PLANNING & HERITAGE STATEMENT

Site: 1-15 Queen Victoria Street / 145-148 Friar
Street, Reading RG1 1SY
Application by: The Thackery Estates
Lead Consultant: Mr Paul S Bottomley
Date: 8th September 2025.
Our Ref: URB-482b-ST13a.

1.1 This planning statement is prepared by Mr Paul S Bottomley BA (Hons), MA, MRTPI of Town Planning Bureau and is presented in support of a planning application under Section 96a of the Town and Country Planning Act 1990 (“96a”) for a non-material amendment to planning permission ref: 240422 and Section 19 Planning (Listed Building & Conservation Act) 1990 (“S19”) for an amendment to listed building consent ref: 240404 (“the application”).

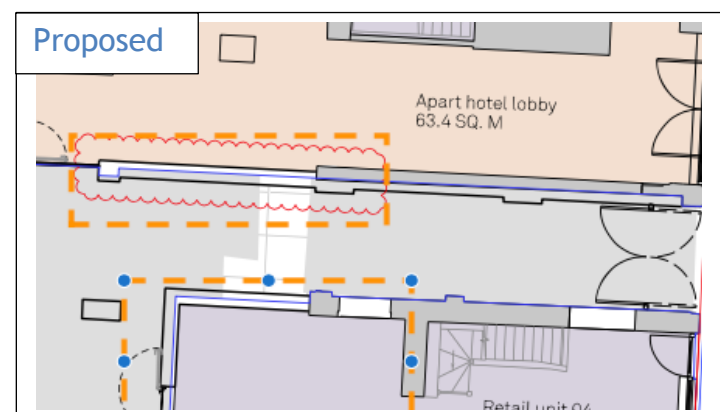
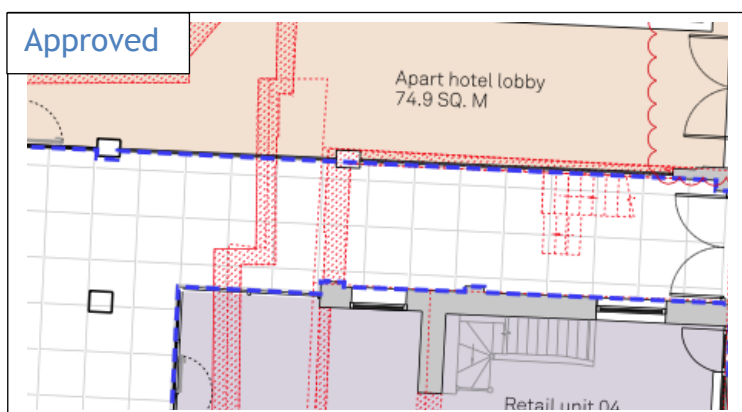
- 1.14 The changes are best highlighted on the comparison drawings below.
- 1.15 Ancillary Area: the Operator does not require the ancillary space and proposes to re-site the cycle store into a newly created courtyard. The WCs, comms & store is relocated to alternative location in the GF. A detailed drawing of the cycle store accompanies. The improved quality cycle store and increased number of bike stands is required by the Operator and is a BREEAM target item to assist with meeting BREEAM requirements. Below shows the ground floor changes been the approved and proposed change below.

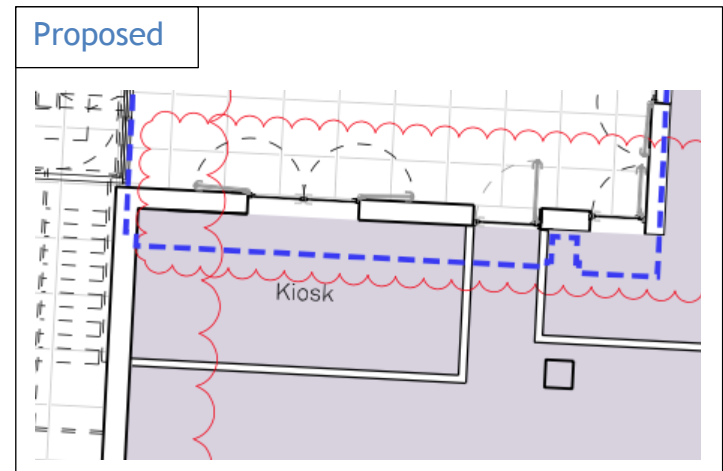
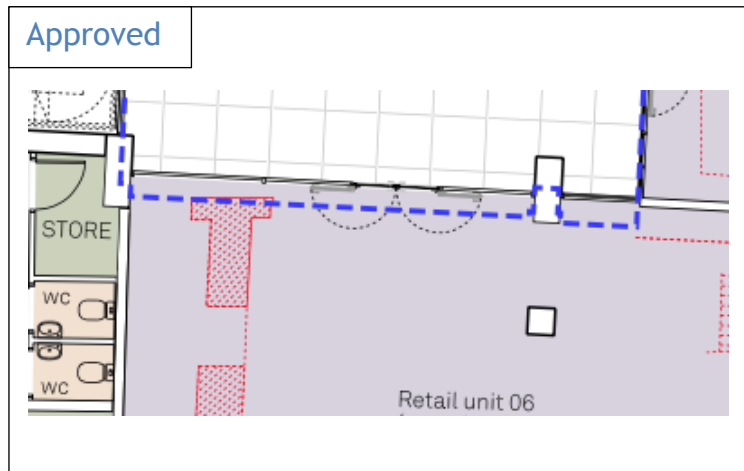
- 1.16 Building Regulations: below shows the ground floor changes been the approved and proposed changes to the means of escape from the courtyard to the QVS - a protected passage is required to meet Building Regulations as this is a protected means of escape. The direction of door opening has been changed to also open out.

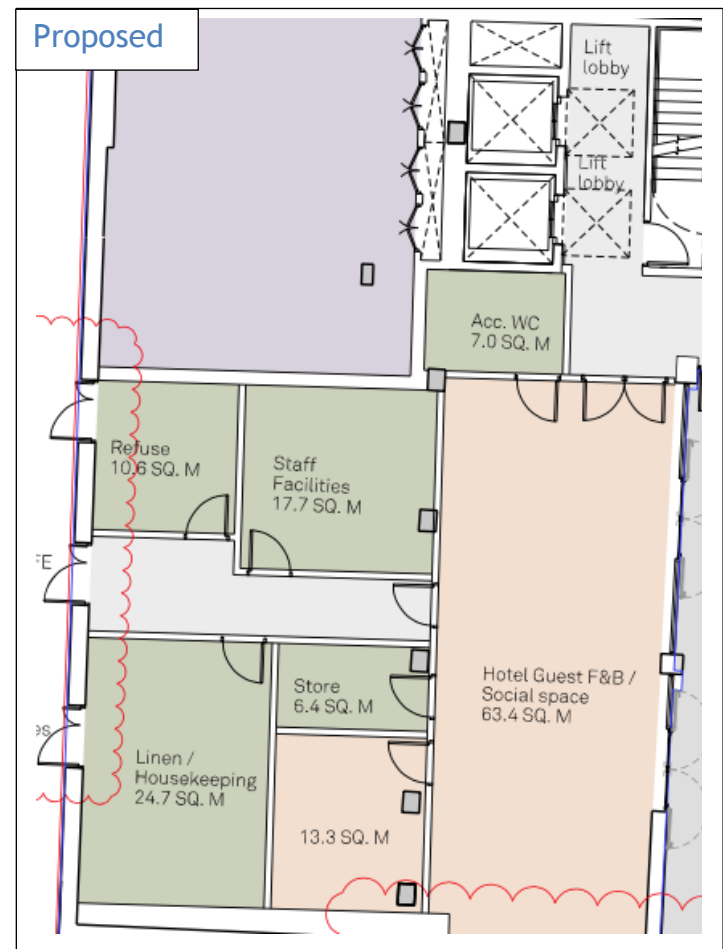
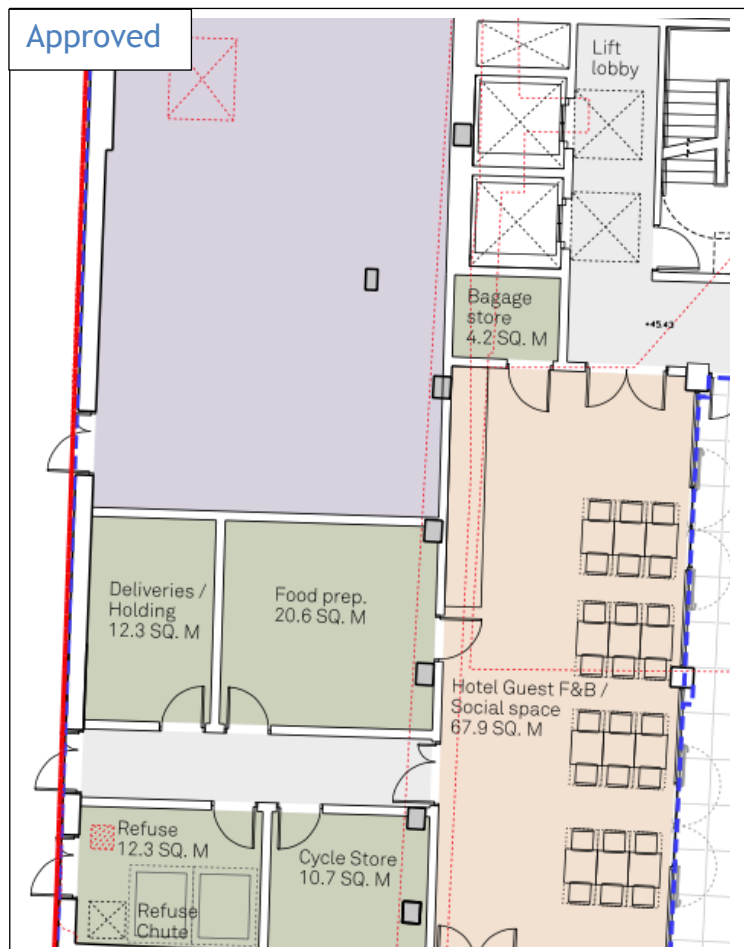
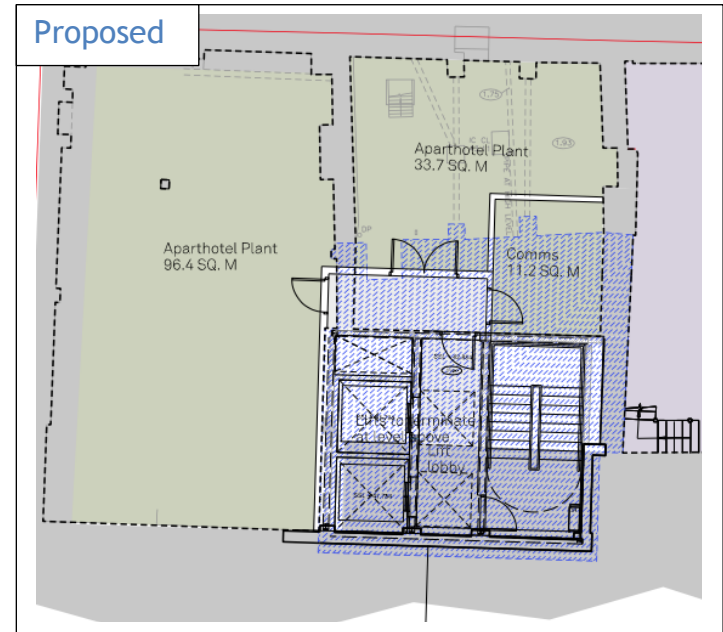
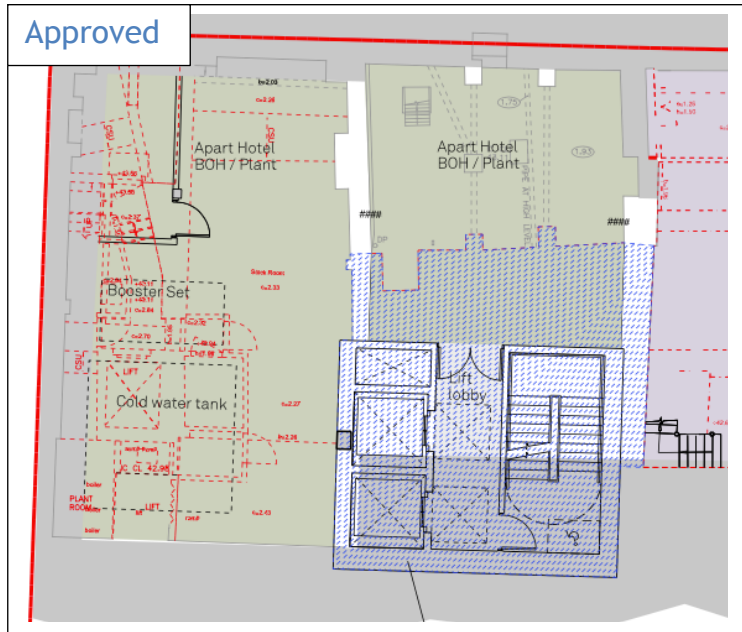
- 1.17 Retail Kiosk: a pop-up Retail Kiosk is proposed in Unit 06 that would be associated with the aparthotel and servicing the courtyard, this would operate in Class E and therefore not result in a material change in use nor reduction in floor area.

- 1.18 Back of House: the operator of the aparthotel has requested to amend the back of house area at GF and BF, these changes are required for operational requirements. As a consequence of the change there is a slight reduction of the retail floor area of Unit 1. Further as the BoH changes, the side elevation doors need to be shifted position.

Amendments to Side Elevation Fenestration

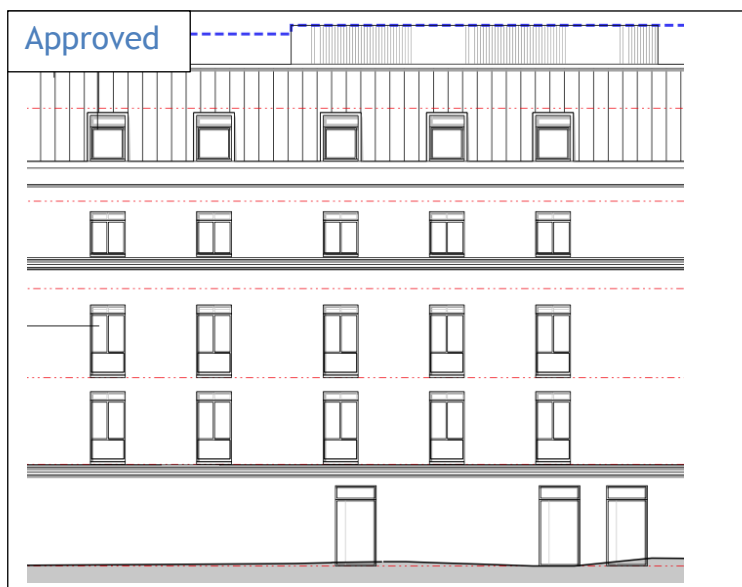
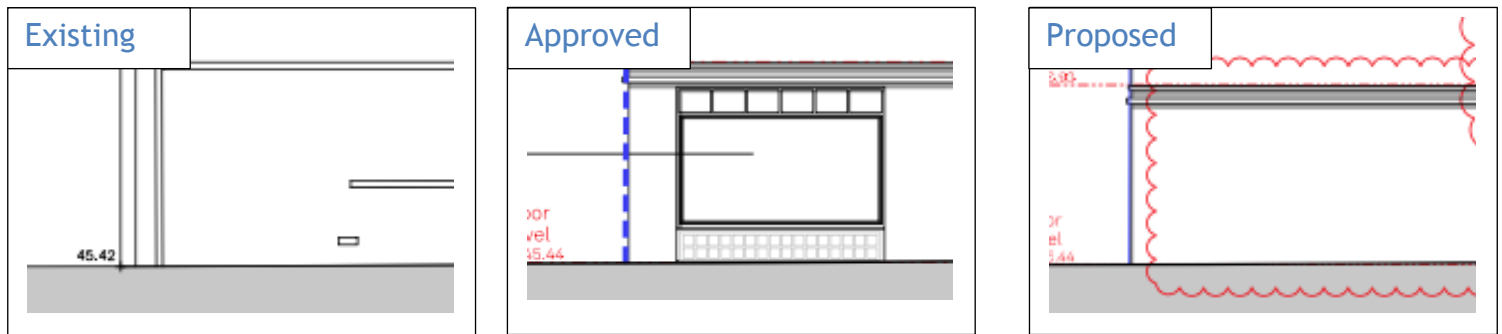
- 1.19 Fenestration: the Operator of the aparthotel has proposed some minor internal changes that has an impact on fenestration to the side elevation.

- 1.20 145 Friar Street: the side elevation of No.145 sits within Fife Court, which is a service road. This area has been subject to allot of anti-social behaviour, including vandalism, spray painting and destruction of property. The large glazed window set back from Friar Street is a significant concern for the future tenant and they are seeking that the window is omitted due to on-going maintenance costs. To fix and repair a window of this size is in the thousands of pounds and placing a large window, set back is a clear risk that has occurred on other sites. In any event, this shop unit does not have a side elevation window as existing.

Internal Changes to Aparthotel Rooms

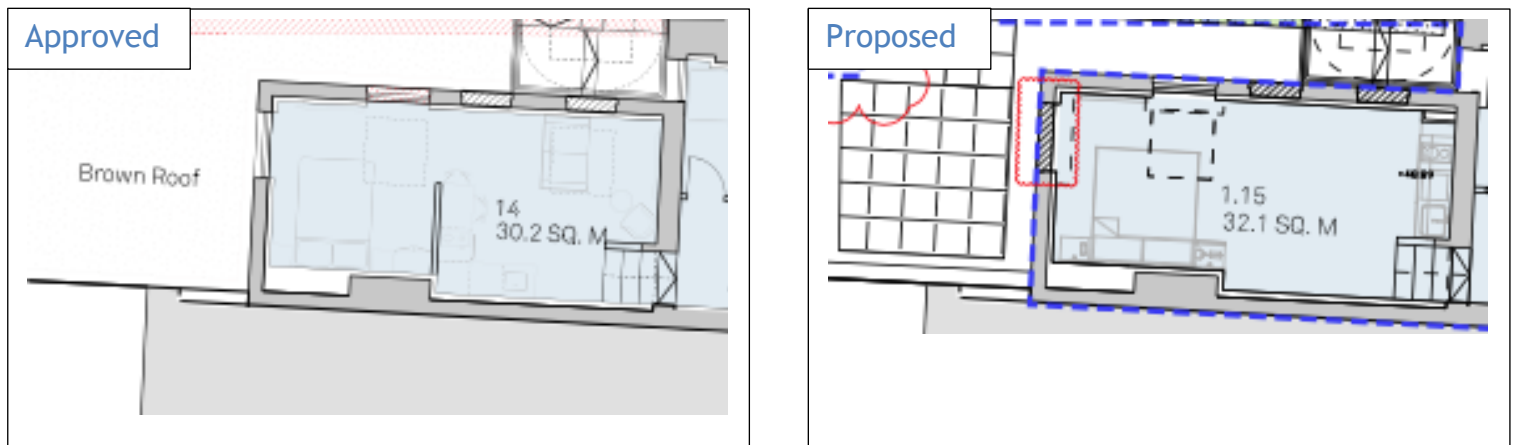
- 1.21 **Layout:** the Operator of the aparthotel has proposed some minor internal changes, however, the number of rooms remains the same. There has also been some modest changes to ancillary rooms not required.
- 1.22 **Fenestration:** one room will have a change to the fenestration of Room 1.15 - the said room will benefit from a side window and rooflights.

Plant Area Zone to 1-15 Queen Victoria Street

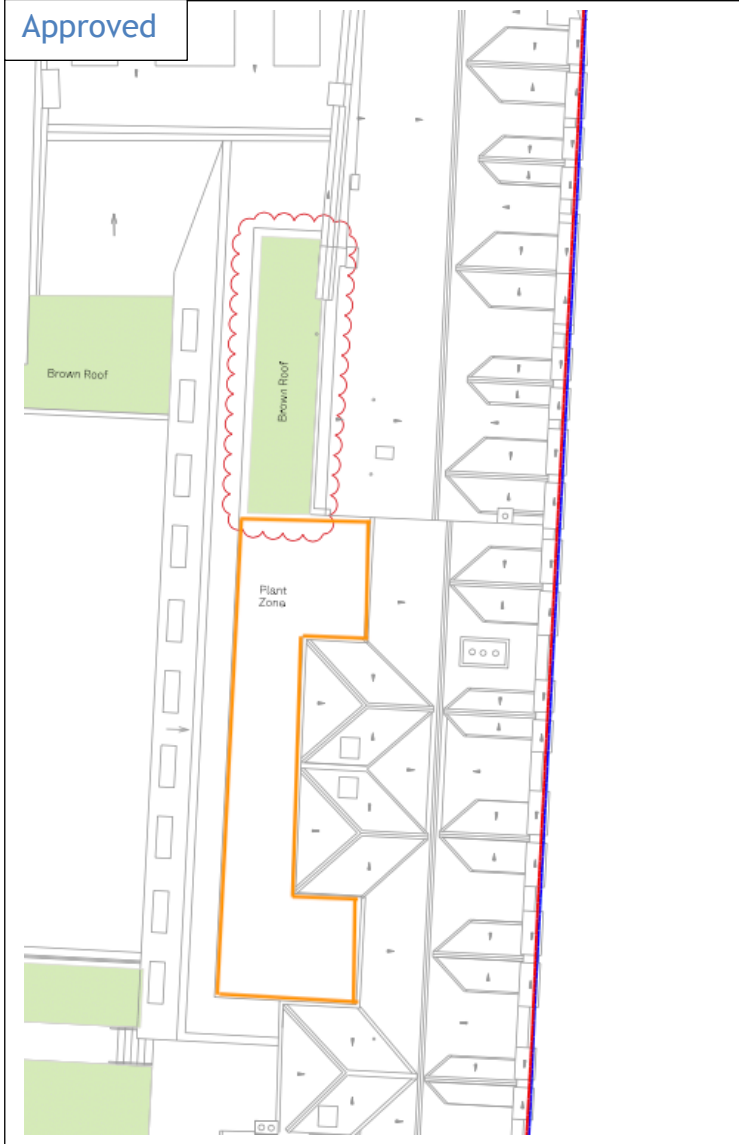
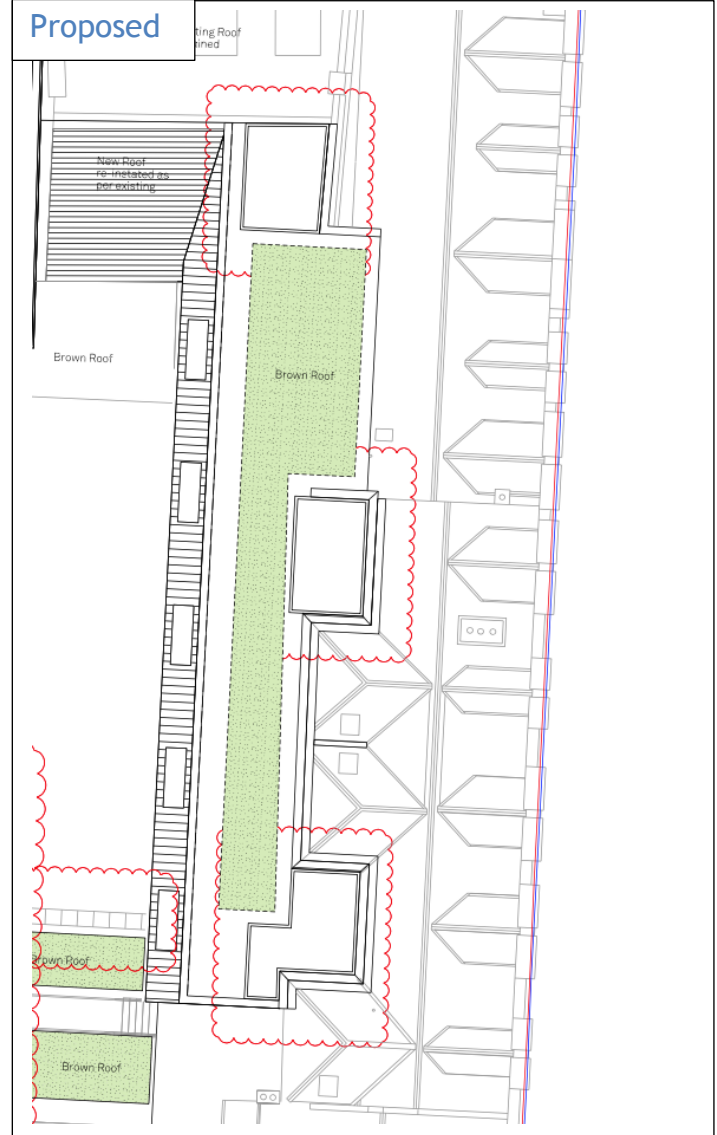
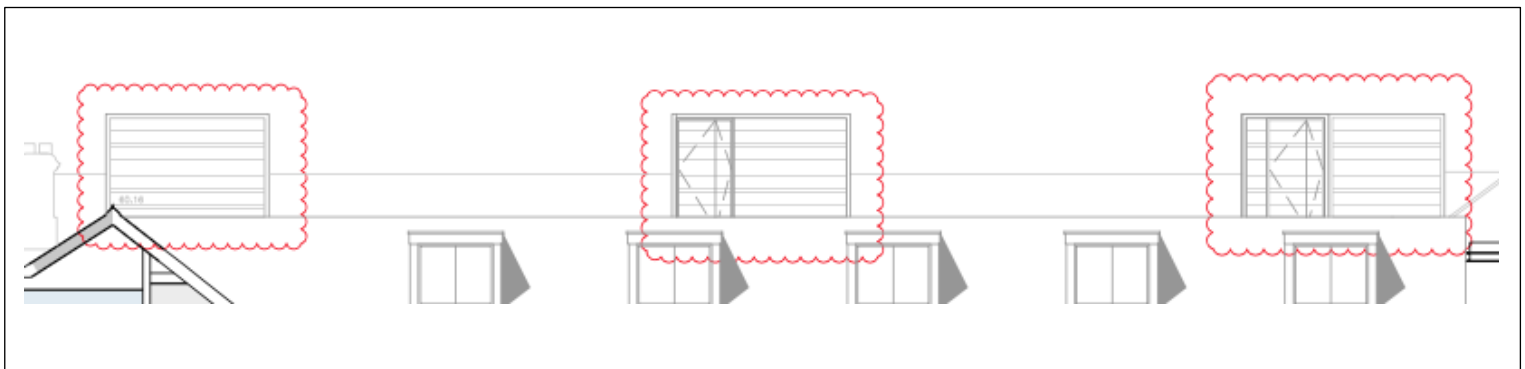
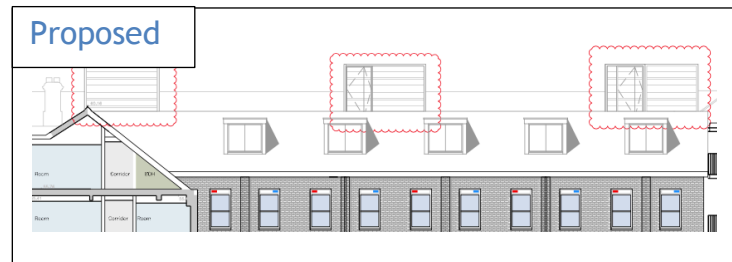
- 1.23 **Plant:** the approved scheme proposed a plant zone at roof level that comprises the majority of the roof. This is shown on the approved drawing. As the detailed design has been progressed the detailed requirements for the air handling has been formalised and this allows a reduction in the size of the plant zone and enclosures.
- 1.24 The scheme now proposes only three more modest zones / enclosures, which are sited in the recess to the rear of the hipped roof of the building ensuring they are screened from public vantage points.
- 1.25 The reduction to the plant zones allows the brown roof area to be increased in extent.

Plant Area Zone to 145 to 146 Friar Street

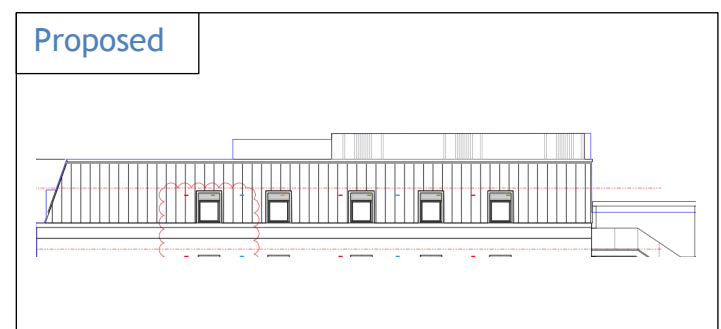
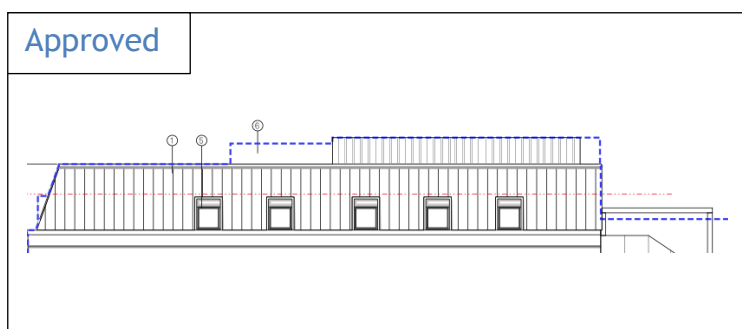
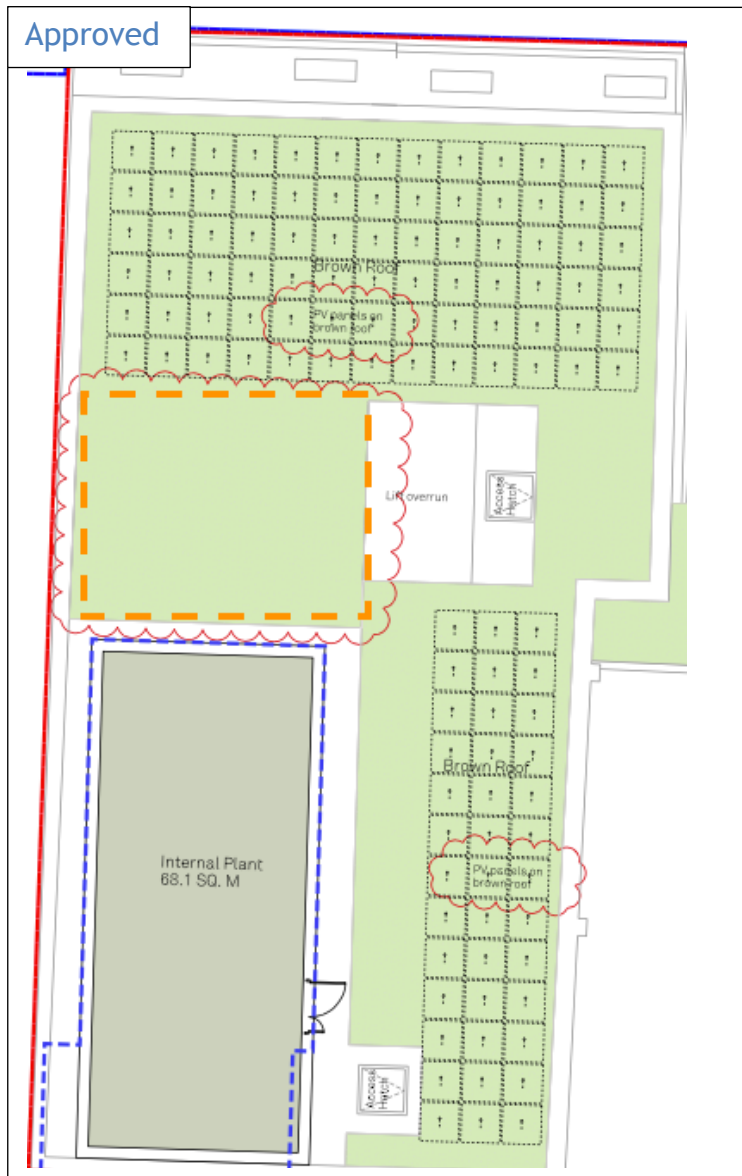
- 1.26 Plant: the approved scheme proposed a plant zone has already been reduced, the hatched orange area was omitted by planning permission ref: 221232. Full design development has confirmed the lift overrun, plant for Unit 2 and access hatch. The main plant zone is confirmed. A benefit is a the area of PV panels proposed can now be confirmed and detailed.
- 1.27 The roof level changes are non-material change to the scheme.

Parapet Reduction 145 to 146 Friar Street

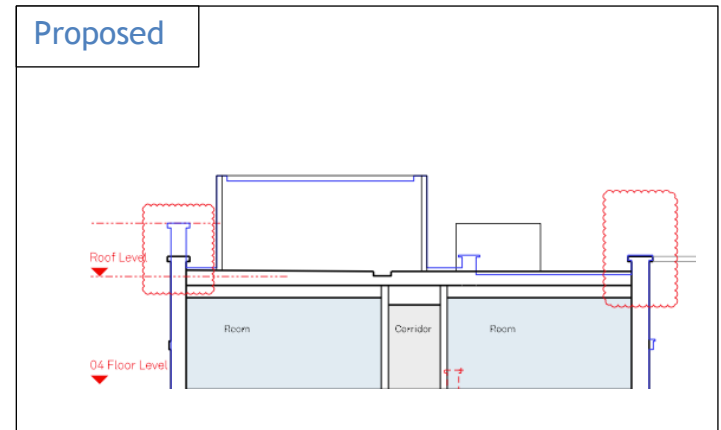
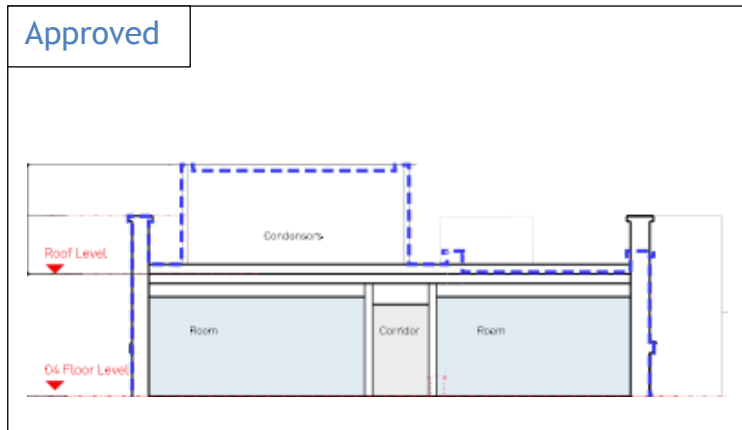
1.28 **Parapet:** the building benefits from a parapet to the roof of 145 to 146 Friar Street. Again, detailed design has established the actual massing of the parapet, which is reduced to further reduce the mass in bulk of the building.
